**Champlain Hudson Power Express ("CHPE")
Environmental Management & Construction Plan
Notice of Major Change**

Project: Champlain Hudson Power Express

Segment: 08

Notice Number: 094

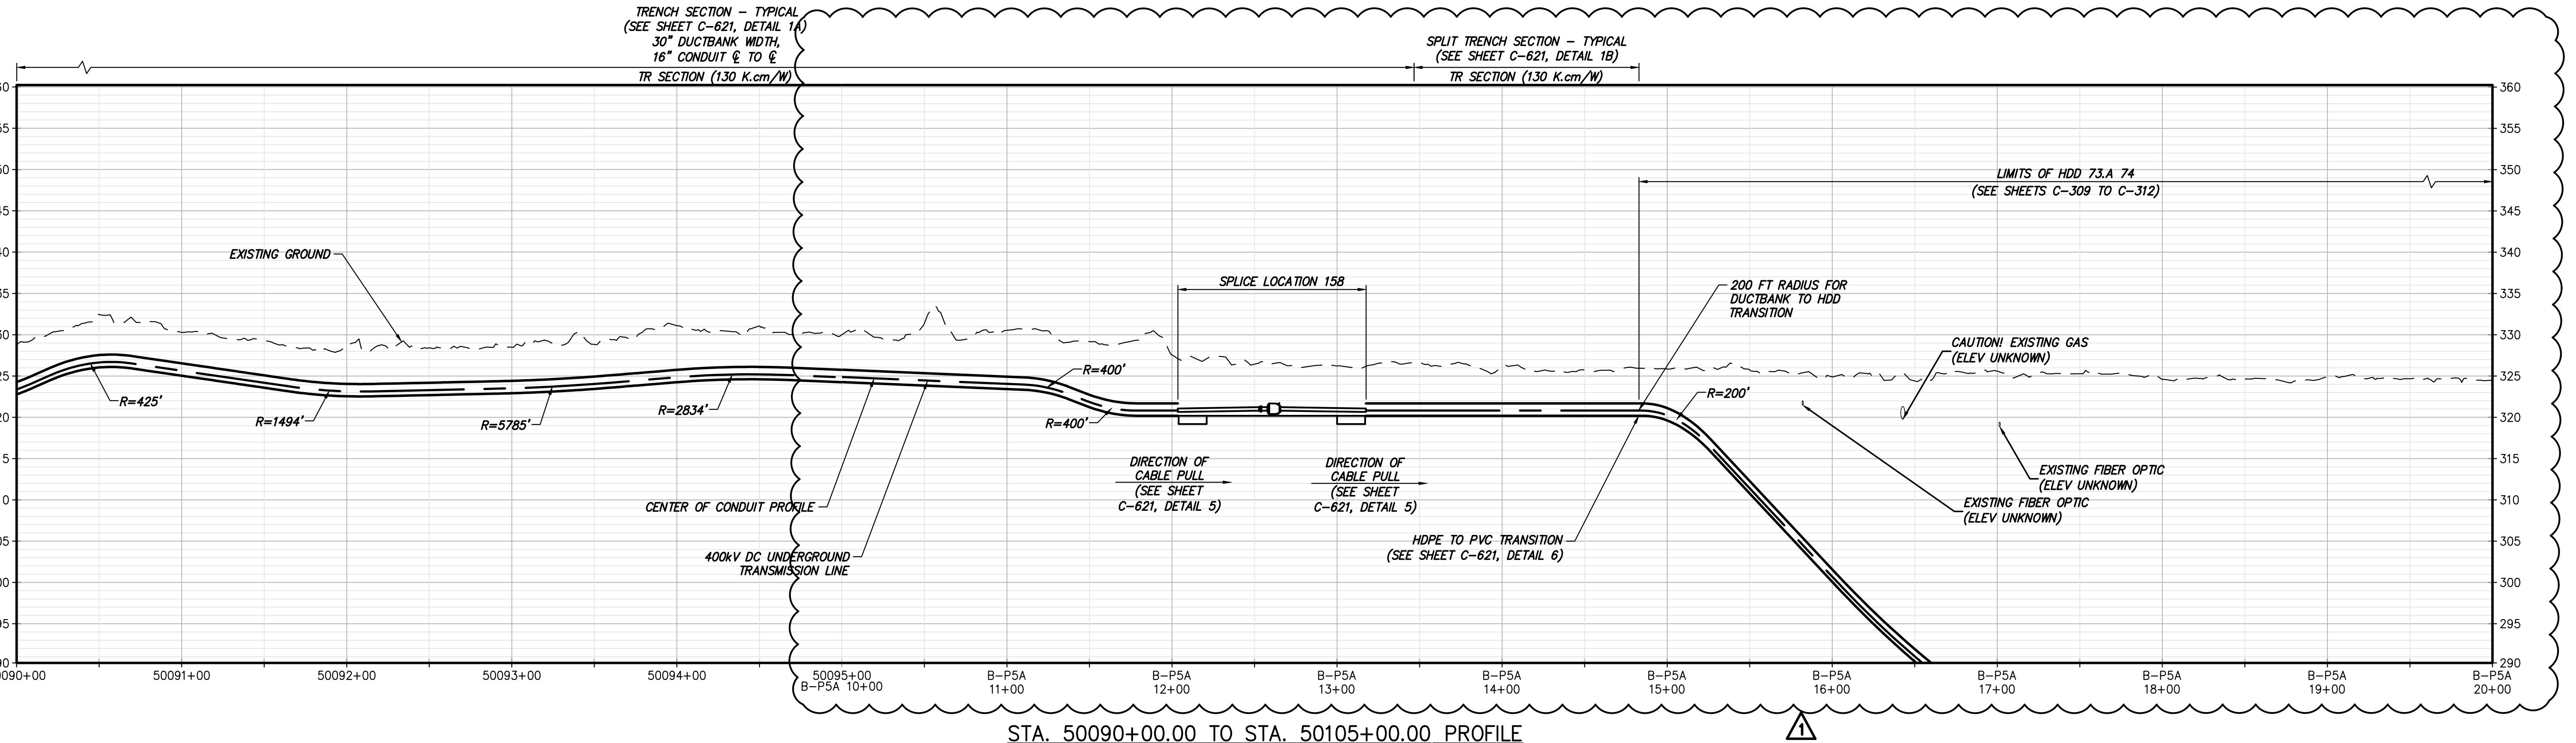
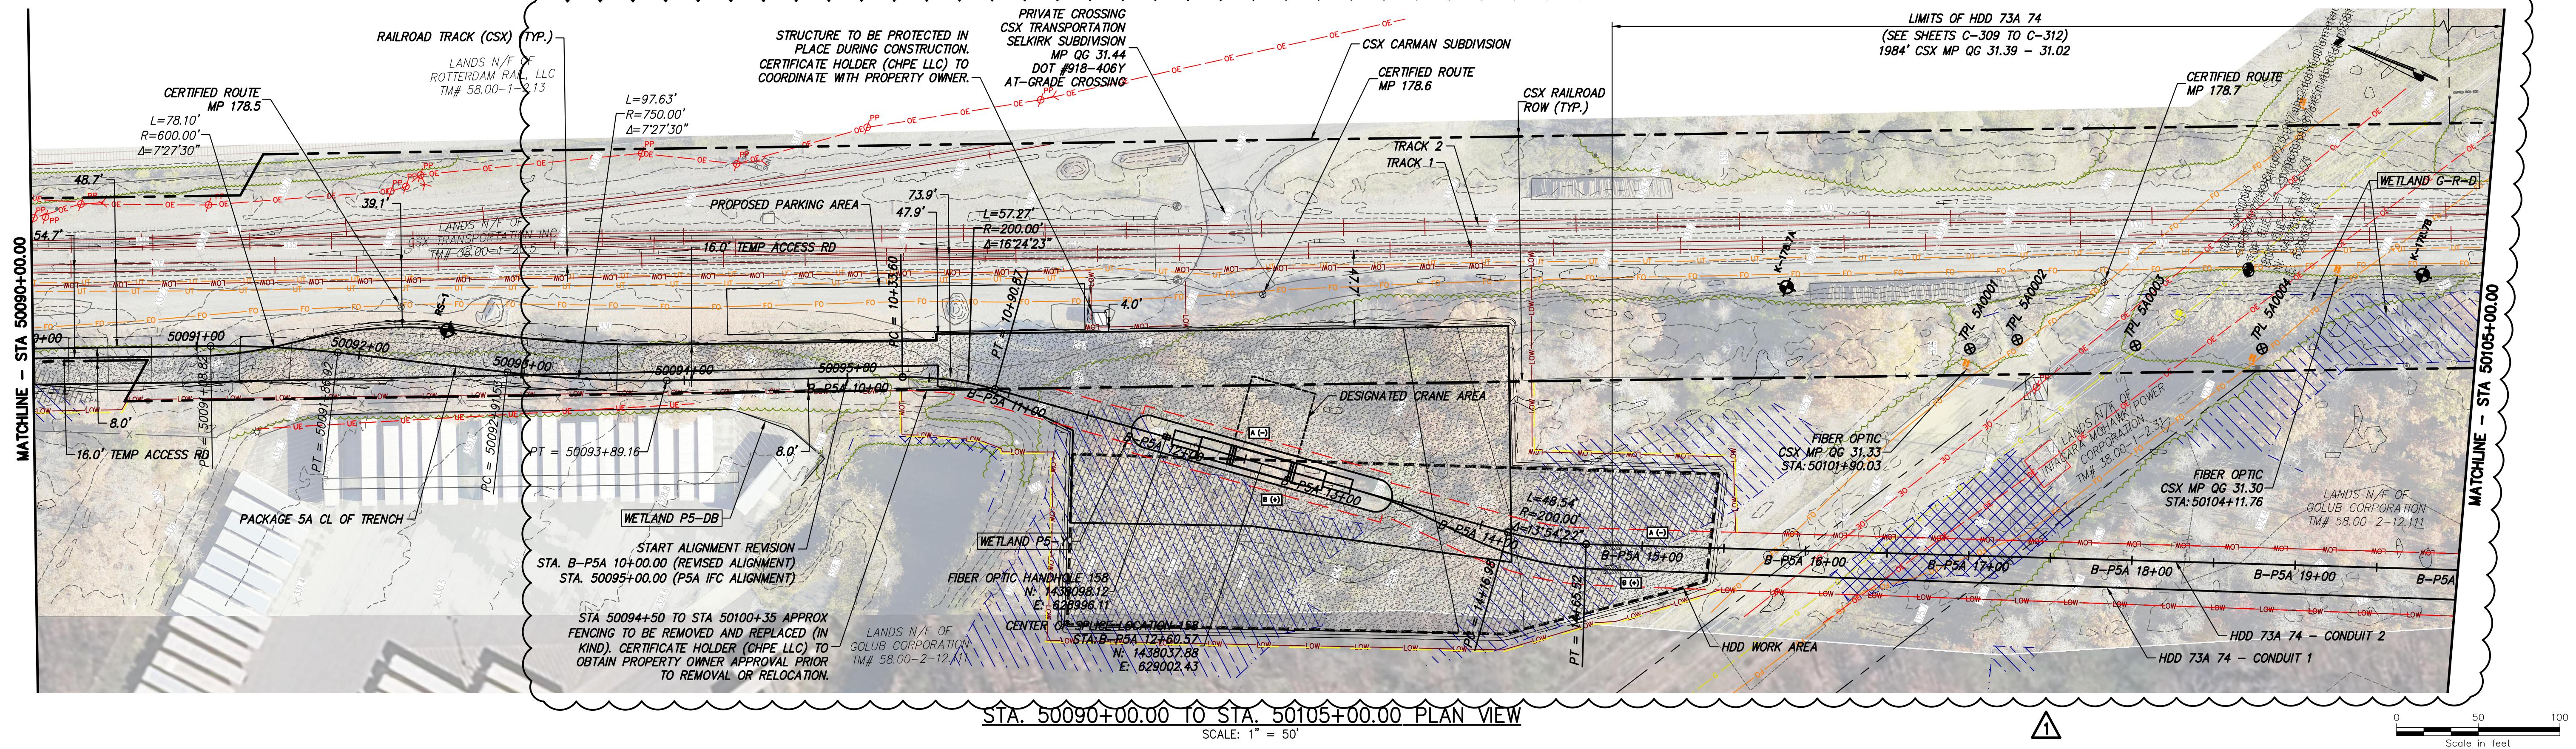
Sheet No.	Rev No.	Revision Description	Summary
C-107	1	NDC-0020_HDD 73A Redesign	HDD 73.A/74 Alignment revised near National Grid Transmission Towers to achieve required clearances per NG Comments. This includes a revised location for Splice Location #158. The revised alignment starts at IFC Alignment STA. 50095+00.00, ends at IFC Alignment STA. 50127+85.00
C-108	1	NDC-0020_HDD 73A Redesign	HDD 73.A/74 Alignment revised near National Grid Transmission Towers to achieve required clearances per NG Comments. The revised alignment starts at IFC Alignment STA. 50095+00.00, ends at IFC Alignment STA. 50127+85.00
C-109	1	NDC-0020_HDD 73A Redesign	HDD 73.A/74 Alignment revised near National Grid Transmission Towers to achieve required clearances per NG Comments. Additional utility survey was performed and incorporated for the "LANDS N/F OF LAWRENCE G. WHITE TM# 58.14-1-4.21". The revised alignment starts at IFC Alignment STA. 50095+00.00, ends at IFC Alignment STA. 50127+85.00

C-309-A
DRAWING NO.
C-309

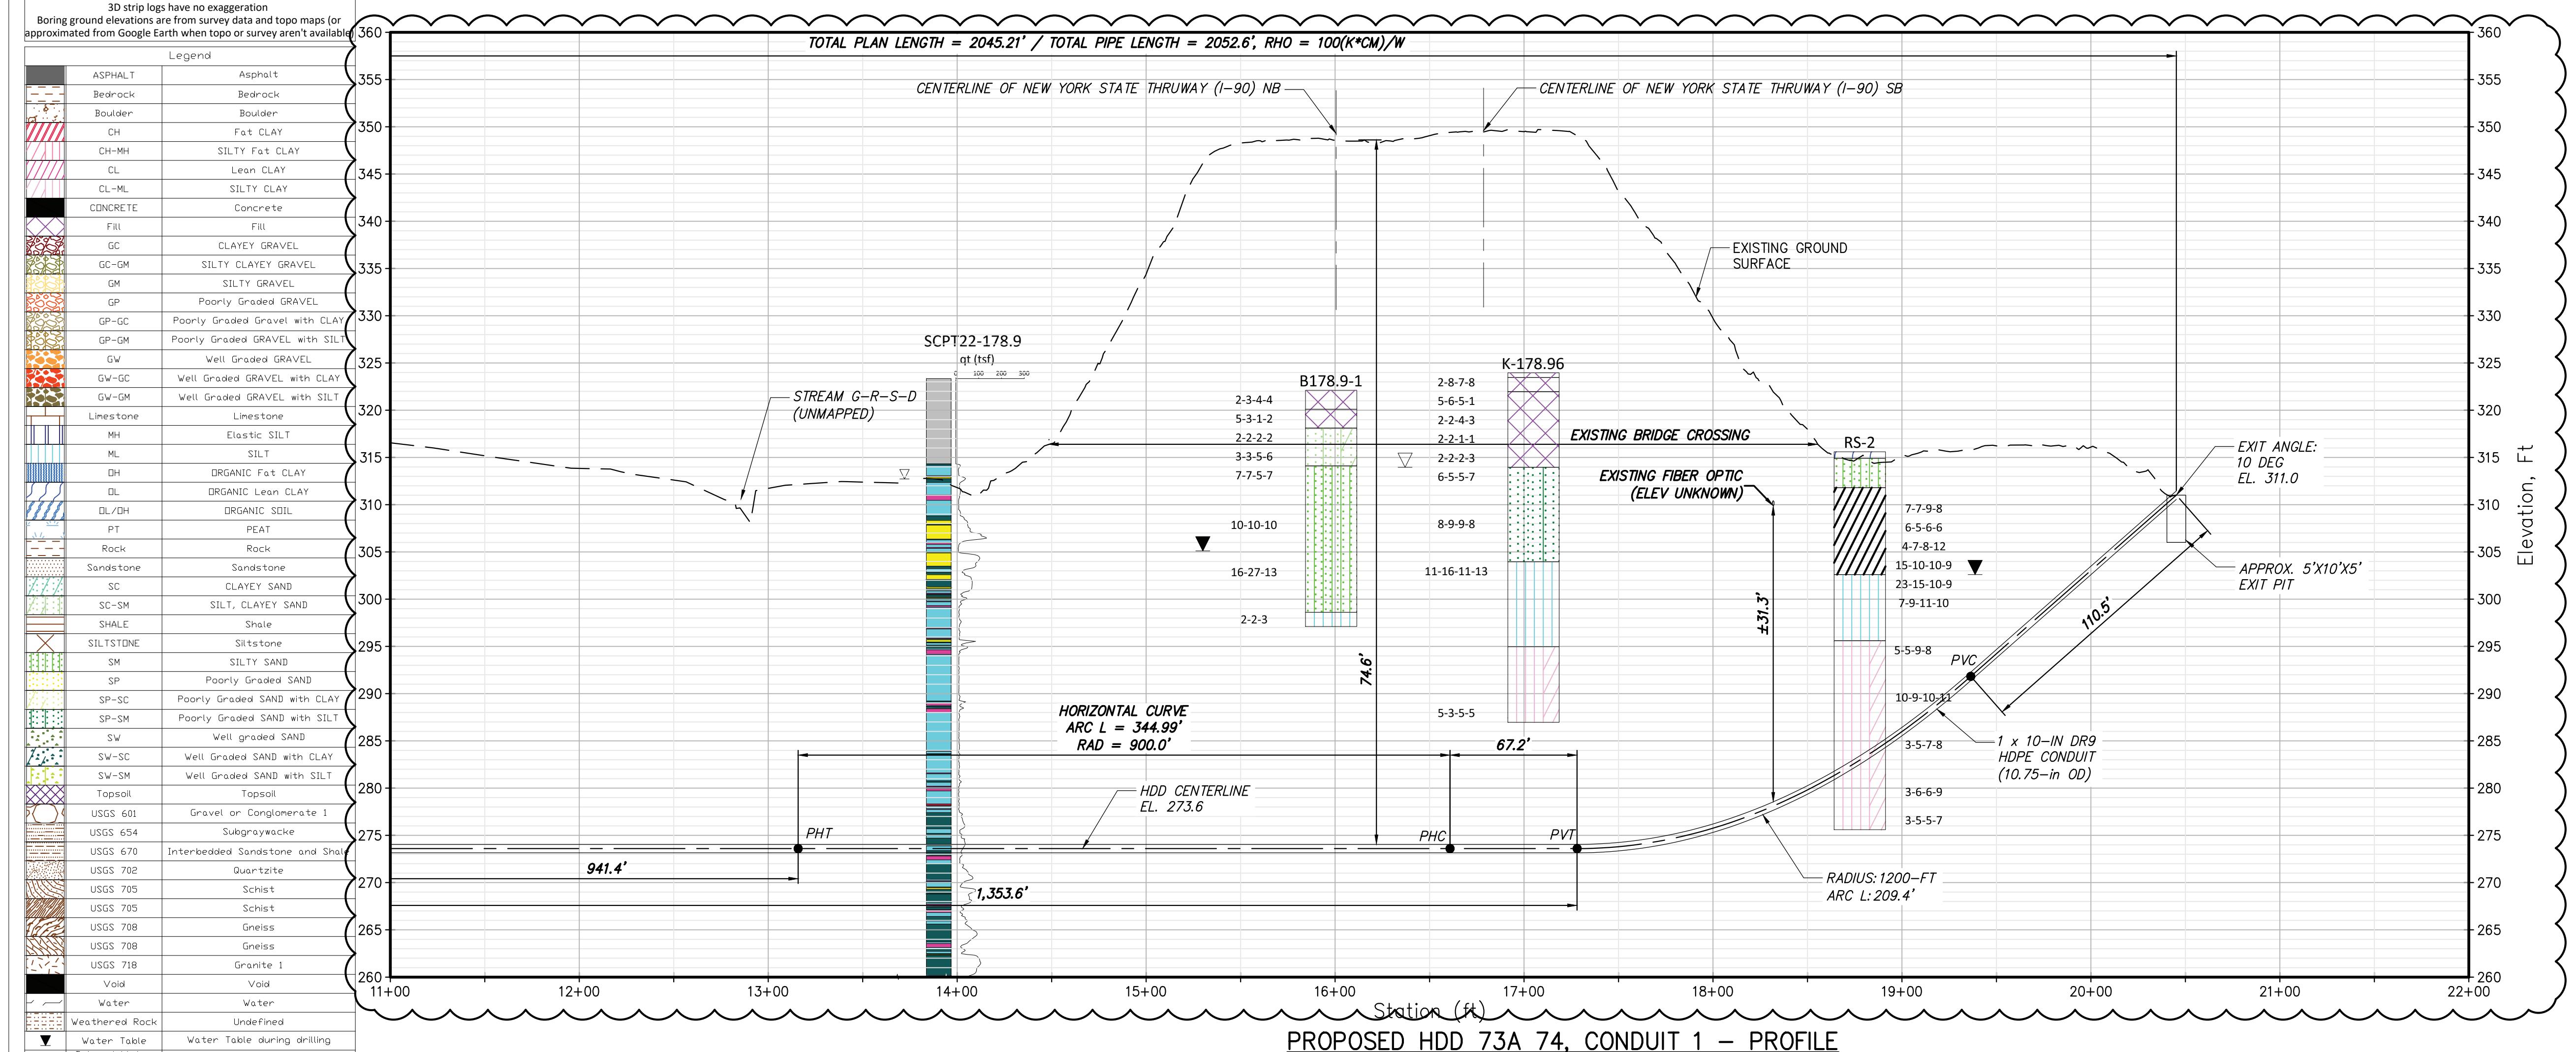
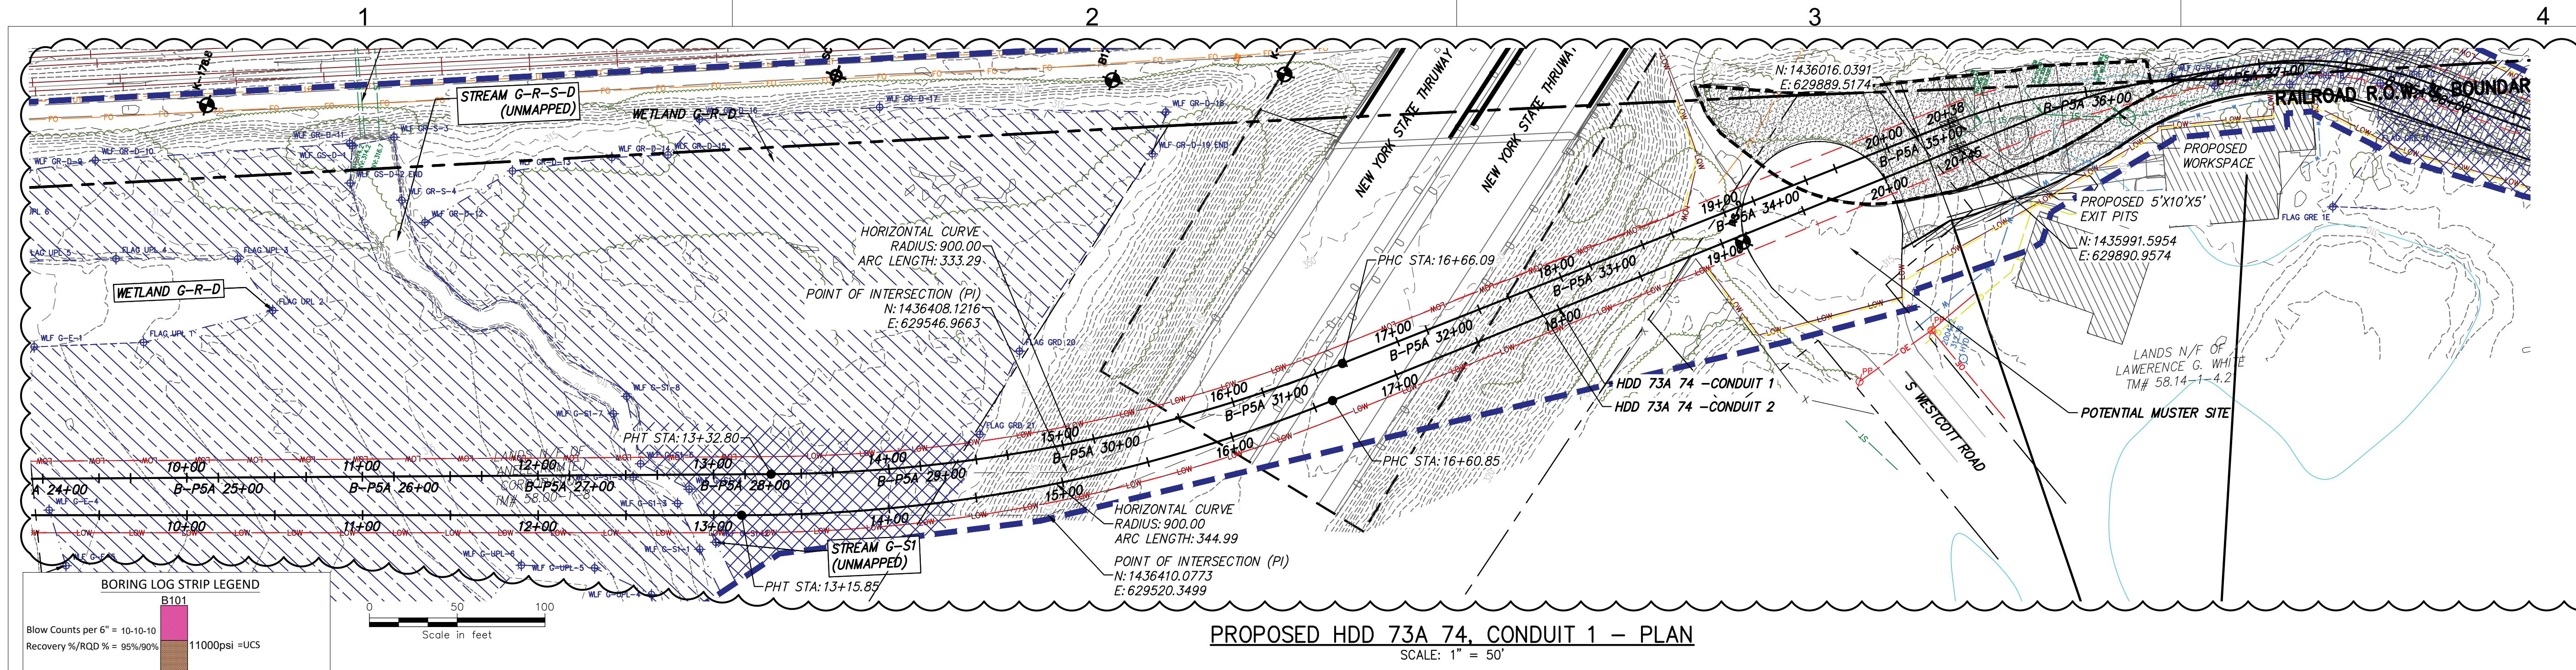
No.	Date	Submittal / Revision Description	DB	APP	Drawn By: BC	Designed By: NS	Approved By: BD	Scale As Shown
1	03/14/2024	NDC-020: ALIGNMENT REVISIONS PER NAT. GRID COMMENT	NS	BD				
0	03/24/2023	ISSUED FOR CONSTRUCTION SUBMISSION	NS	BD				
No.	Date	Submittal / Revision Description	DB	APP	Drawn By: BC	Designed By: NS	Approved By: BD	Scale As Shown

C-309	1	NDC-0020_HDD 73A Redesign	HDD 73.A/74 Alignment revised near National Grid Transmission Towers to achieve required clearances per NG Comments. The revised alignment starts at IFC Alignment STA. 50095+00.00, ends at IFC Alignment STA. 50127+85.00
C-310	1	NDC-0020_HDD 73A Redesign	HDD 73.A/74 Alignment revised near National Grid Transmission Towers to achieve required clearances per NG Comments. Additional utility survey was performed and incorporated for the "LANDS N/F OF LAWRENCE G. WHITE TM# 58.14-1-4.21". The revised alignment starts at IFC Alignment STA. 50095+00.00, ends at IFC Alignment STA. 50127+85.00
C-311	1	NDC-0020_HDD 73A Redesign	HDD 73.A/74 Alignment revised near National Grid Transmission Towers to achieve required clearances per NG Comments. The revised alignment starts at IFC Alignment STA. 50095+00.00, ends at IFC Alignment STA. 50127+85.00
C-312	1	NDC-0020_HDD 73A Redesign	HDD 73.A/74 Alignment revised near National Grid Transmission Towers to achieve required clearances per NG Comments. Additional utility
